Interconnection Requirements Manual Updates

Distributed Resources Engineering
Joel Hornburg, Marlissa Lucero, and Danny Miranda

Interconnection Requirements Manual (IRM) A Collaborative Update Process

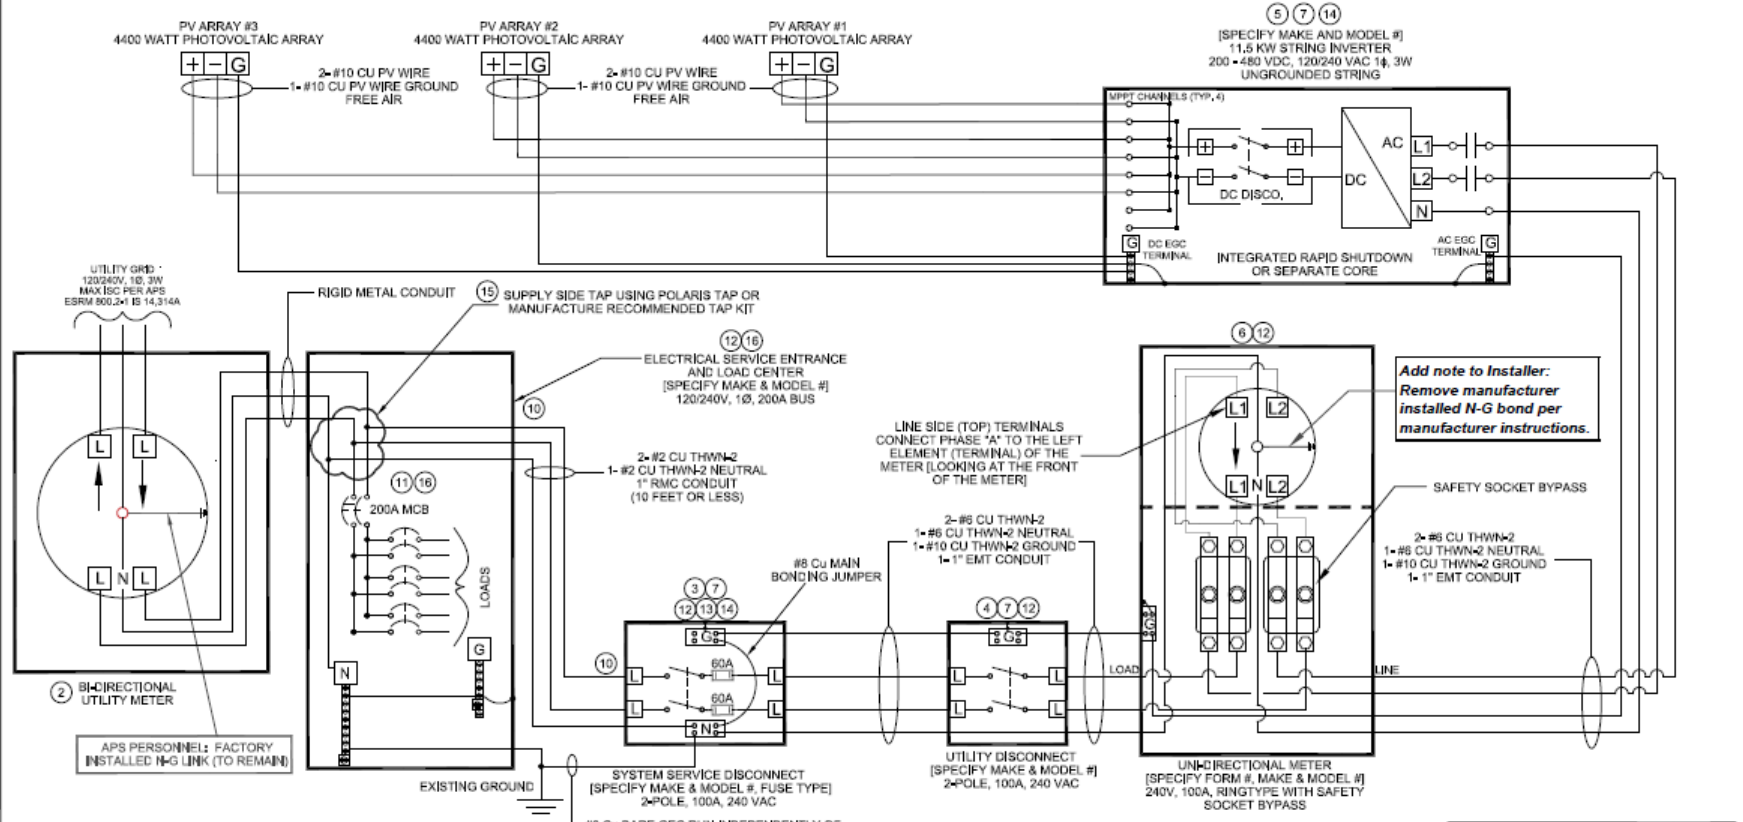
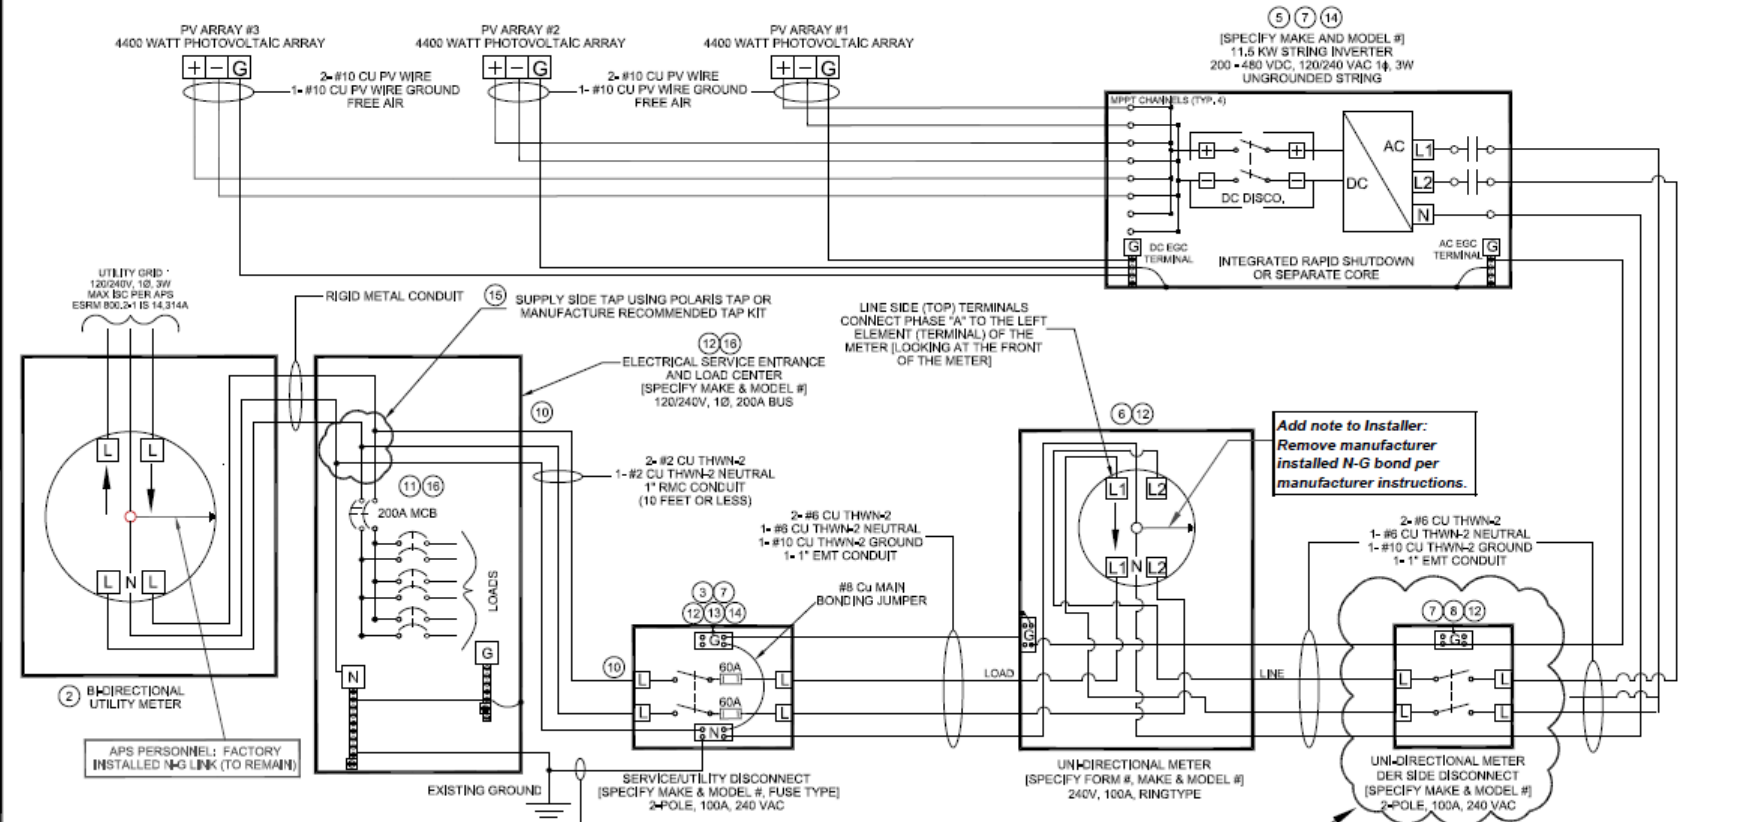
Minimizing the Number of Disconnects (8.6)

Approved Fused Disconnects may be used for all applications

- BIDIRECTIONAL UTILITY METER INSTALLED BY UTILITY COMPANY.
 - LABEL "SERVICE/UTILITY DISCONNECT," KEEP COVER LOCKED; SWITCH MUST SHOW VISIBLE OPEN, INSTALL PER UTILITY REQUIREMENTS AND NEC 705.20, ACCEPTABLE OPTIONS; (1) SWITCH WITH VISIBLE WINDOW AND CUSTOMER-INSTALLED LOCK, OR (2) A SHARED LOCK PER UTILITY REQUIREMENTS.

- REQUIRED FOR GRID FORMING SYSTEMS, LABEL "UNIDIRECTIONAL METER DER SIDE DISCONNECT SWITCH," SWITCH COVER TO BE LOCKED AT ALL TIMES, AND SHALL BE VISUAL OPEN AND ACCESSIBLE PER UTILITY REQUIREMENTS AND CONFORM TO NEC 705.20.

NOTE: ONLY NEEDED FOR GRID FORMING SYSTEMS, SEE NOTE #8

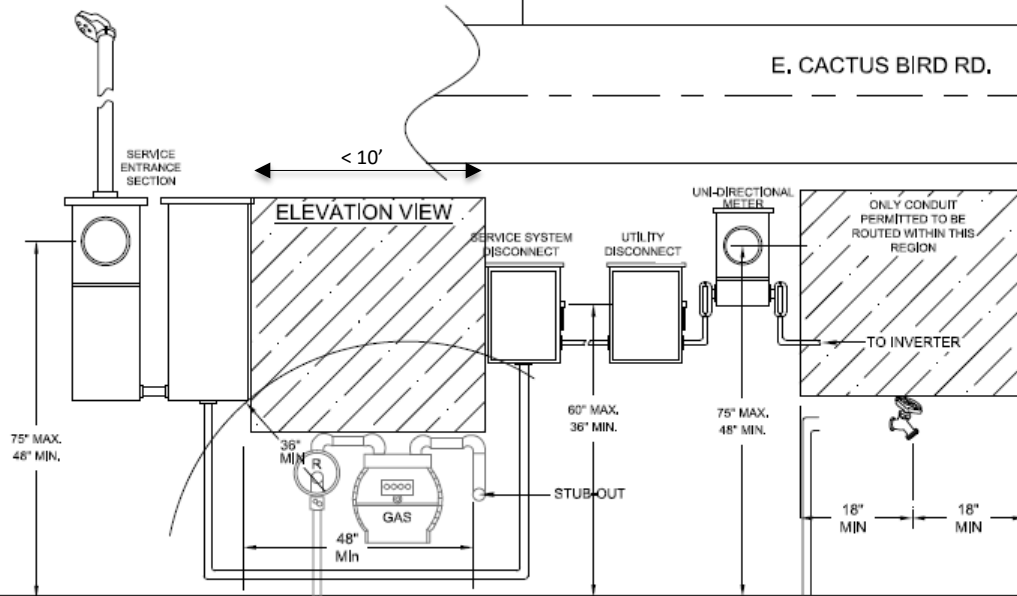
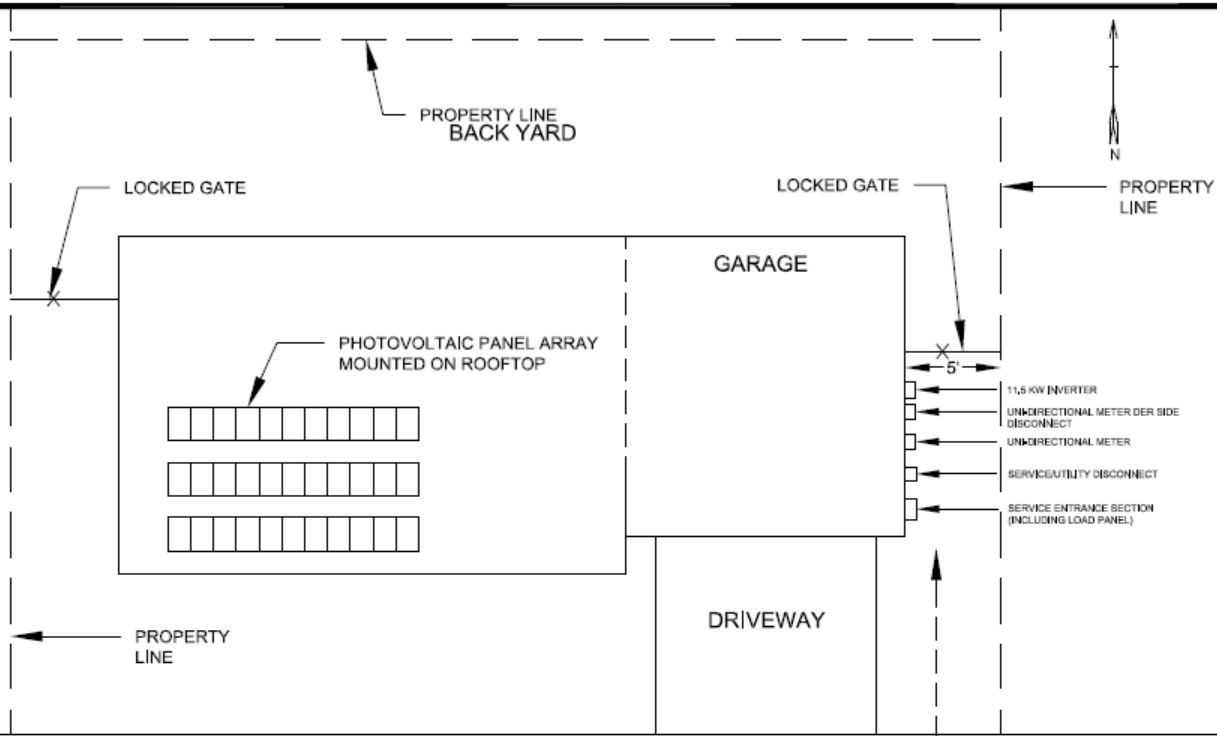
Clarification of Equipment Locations and Access (8.2)

- Location of new production equipment may be adjacent to the existing SES even when located in a fenced yard
 - Customers may be contacted to schedule an appointment to access the equipment

New:

NOTE: UTILITY PERSONNEL REQUIRE COORDINATED ACCESS TO ALL DER SYSTEM COMPONENTS, SERVICE DISCONNECTS, METERING, AND SERVICE EQUIPMENT FOR SCHEDULED MAINTENANCE AND SAFETY INSPECTIONS. CUSTOMERS ARE RESPONSIBLE FOR ENSURING THAT ACCESS IS AVAILABLE AND MAY BE CONTACTED BY THE UTILITY TO ARRANGE SITE VISITS WHEN EQUIPMENT IS LOCATED WITHIN FENCED OR SECURED AREAS. EMERGENCY ACCESS TO THIS EQUIPMENT MUST BE AVAILABLE AT ALL TIMES.
